## 2021/2930/P Rear of Barkat House 116-118 Finchley Road

# The Rotunda . Adjacent to 116 -118 Finchley Rd. NW3 5HT

# 2021/2936/P. Tree report . November 2022.

Please refer to the Tretec plan - TCP

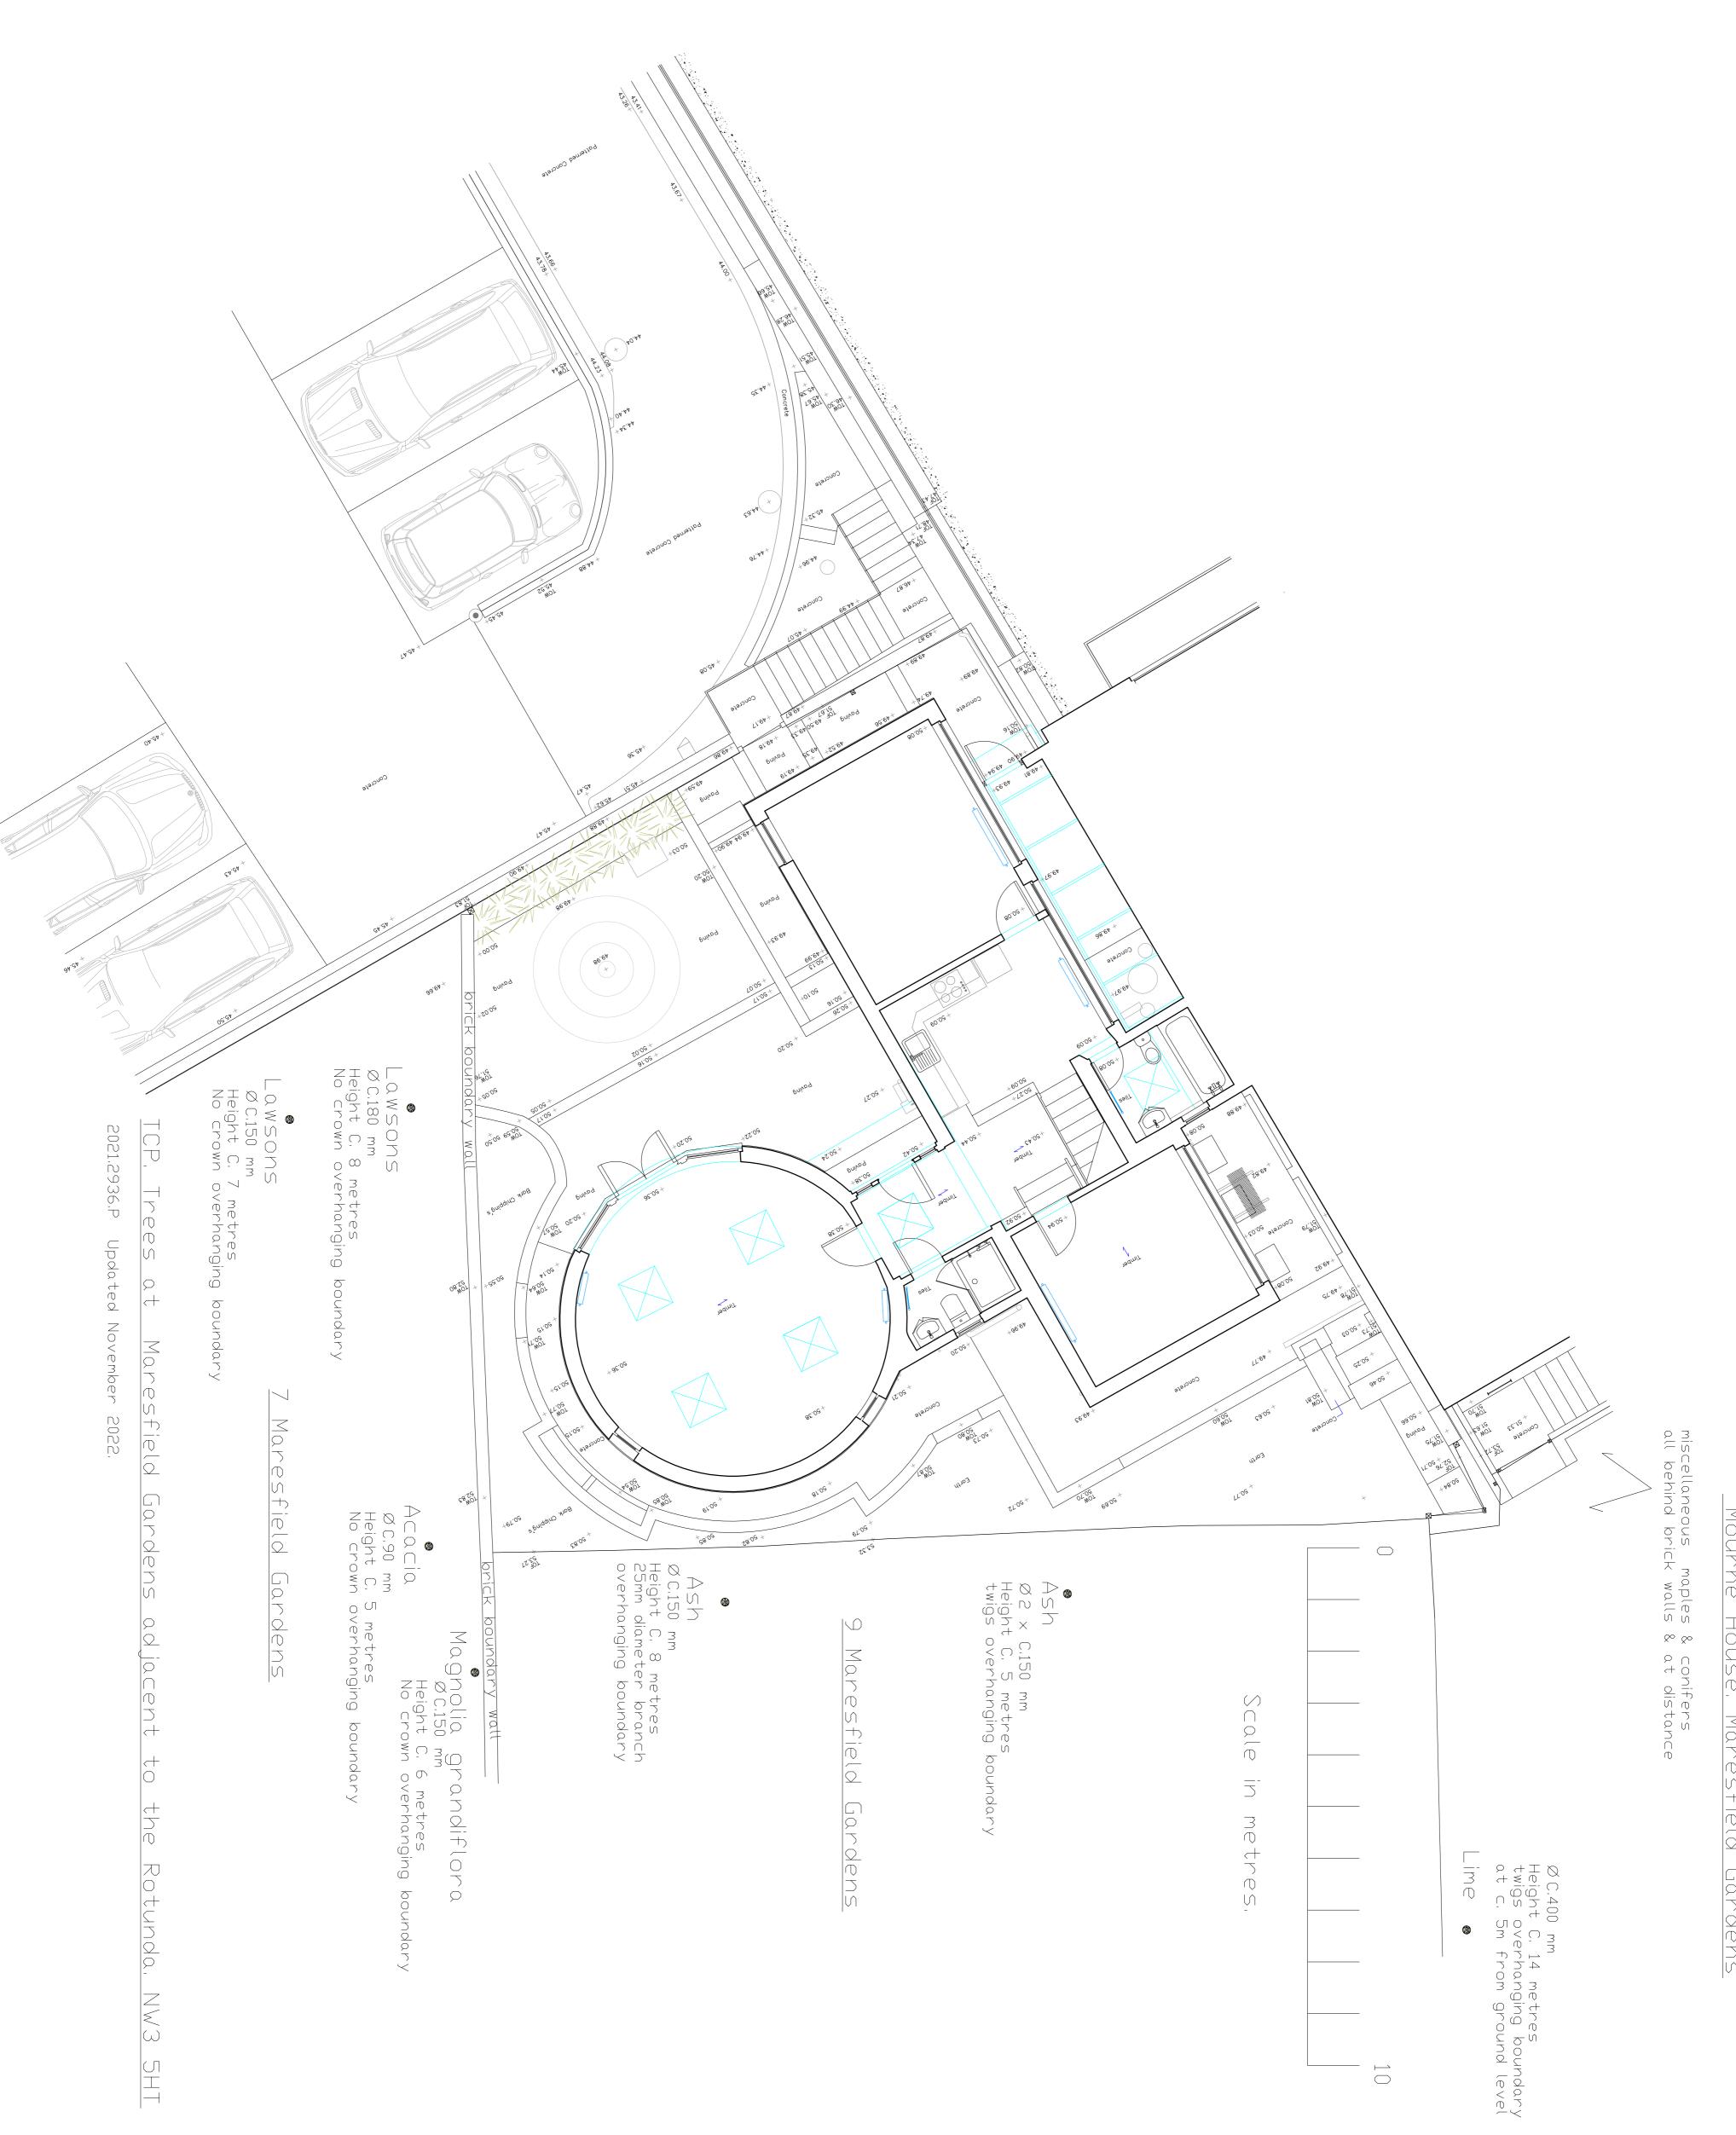
The application has been supported by a tree statement which states that the proposal would have no impact on surrounding trees. The tree statement advises that there are no trees in the garden of no. 9 Maresfield Gardens. When looking through the photos that I took on site there are tree branches above the fencing to the north of the site in the garden of no. 9. This is supported by google earth dated 2020 that cleared shows the crowns of trees in the rear garden of no. 9 in close proximity to the boundary with the application site (see screen shot below). The proposed plans also show the outline of trees in the garden on no. 9?

I have not received comments from the tree officer on the proposal however it would be good to get clarification on this.

Please find attached an updated tree report from Tretec dated November 22 which I hope addresses your queries and comments.

There are no trees at all within the curtilage of Rotunda.

There are no trees adjacent to the western boundary.

The entire southern boundary comprises of a circa 1.8 metre high brick wall. This wall represents a barrier to root growth from the garden of number 7 Maresfield Gardens to the south. Root barriers aside the proposed works would be outside of the normative root protection areas as described in the BS of these trees.

The garden of number 9 Maresfield Gardens contains 2 Ash saplings. Google earth shows a substantial Copper Beech but this has now gone. There is one branch of c25mm diameter overhanging, the rest of this boundary is to all purposes clear of tree branches.

There is one Lime of stem diameter circa 400mm in the garden of Mourne House, Maresfield Gardens. This is at distance from the boundary and again the proposals are behind root barriers and outside the normative root protection area of this tree. All other trees on adjacent to Mourne House are at distance.

It is a considered view that excavations within the curtilage of Rotunda will not affect any of the neighbours trees and therefore the proposal can be built within the aims and intention of the BS.
